Contract #: 04-0120F4Cty: SF/ALA Rte: 80 PM: 13.2/13.9File #: 69.25B**QUALITY ASSURANCE -- NON-CONFORMANCE REPORT****Location:** Changxing Island, Shanghai, China**Report No:** NCR-000857**Prime Contractor:** American Bridge/Fluor Enterprises, a JV**Date:** 06-Oct-2010**Submitting Contractor:** Zhenhua Port Machinery Company, Ltd (ZPMC), Changxing Island**NCR #:** ZPMC-0819**Type of problem:**

Reference Description: Base Metal Repair and inadequate preheat on CB18 Anchor Seat Plates**Description of Non-Conformance:**

Subject: NCR No. ZPMC-0819

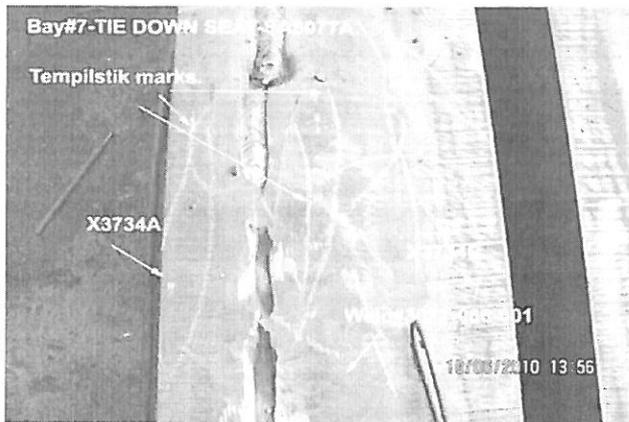
-Additionally, welding was being performed without sufficient preheat.

-This QA Inspector observed a 100 degree Celsius Tempilstik temperature indicator mark applied to the adjacent base material within approximately 30mm from the point of welding did not melt.

-As per the applicable WPS No: 345-SMAW-1G (1F) Repair, required min temperature is 200 degree Celsius.

-The welding was being performed using Shielded Metal Arc Welding (SMAW) in the flat (1G) position.

-The Top Bearing plate is identified as X3734A.

The weld has been accepted with NDT verification. This NCR is closed.
